# Final Safety Evaluation Report To License the Construction and Operation of a Facility To Receive, Store, and Dispose of 11e.(2) Byproduct Material Near Clive, Utah

Docket No. 40-8989  
Envirocare of Utah, Inc.

U.S. Nuclear Regulatory Commission

January 1994

Figure 7 Potentiometric-Head Contour Map

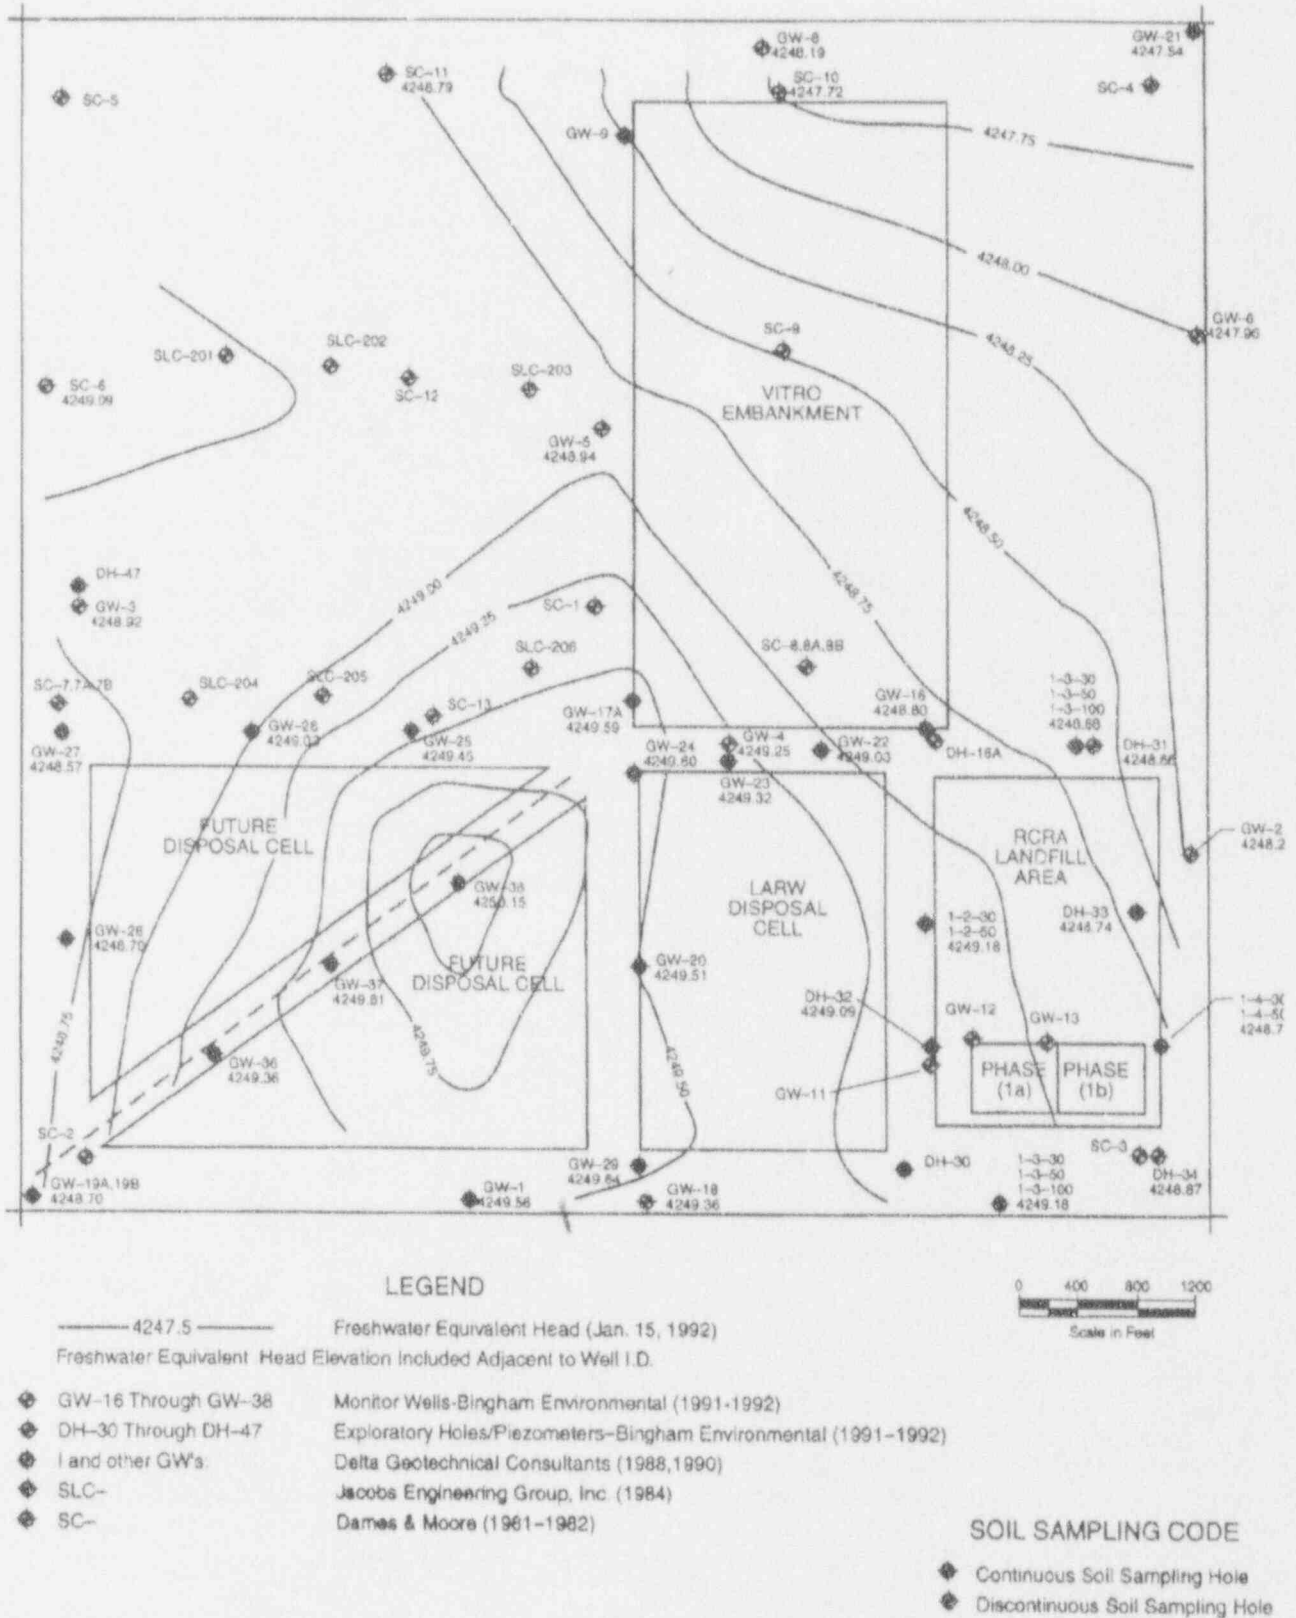
The computed freshwater-equivalent heads were used by Bingham Environmental to prepare potentiometric-head contour maps for February, May, and October 1991, January 1992, and February 1993. Figure 7 provides the potentiometric-head contour map for February 1993; the other potentiometric-head contour maps are provided in the license application documents (Figures 14 through 16, Addendum 1 to Appendix D of the license application (Envirocare, 1993)). The applicant, on the basis of the computed freshwater-equivalent heads for the unconfined aquifer used by Bingham Environmental (Envirocare, 1993), concluded that there is a high potentiometric-head anomaly in the vicinity of well

The high potentiometric-head anomaly in the vicinity of well GW-38 in the disposal site area could be attributed to a significant recharge that the unconfined aquifer may be receiving at that location from the underlying confined aquifer. However, there are no other data to corroborate this finding. In addition, the applicant used estimated specific gravity values in evaluating the freshwater-equivalent heads for some wells, and groundwater gradients in the area of the site are generally small. The staff has determined that the applicant did not provide conclusive evidence as to the direction of ground-water flow in the uppermost aquifer.

Figure 10 Point-of-Compliance Wells

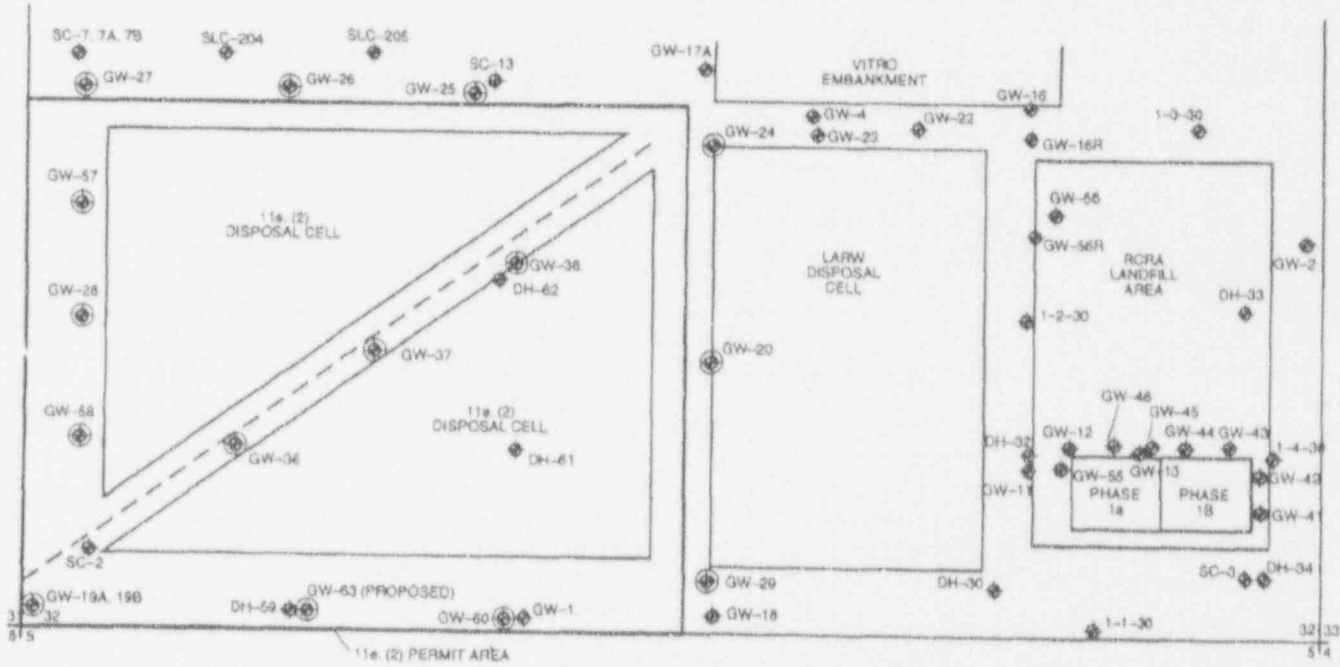
Although the applicant did not offer a satisfactory explanation for the high potentiometric-head anomaly in the vicinity of well GW-38, the resulting potentiometric-head

contours required that the applicant define the point of compliance and provide monitoring in virtually all directions around the disposal embankment, to provide for timely detection of any contaminants reaching the water table from the disposal cell.

Accordingly, the applicant defined the POC in nearly all directions and proposed to include a total of 15 POC monitoring wells that are so located to permit detection of contaminants in virtually all directions from the disposal site (Figure 10). The NRC staff finds the applicant's place-
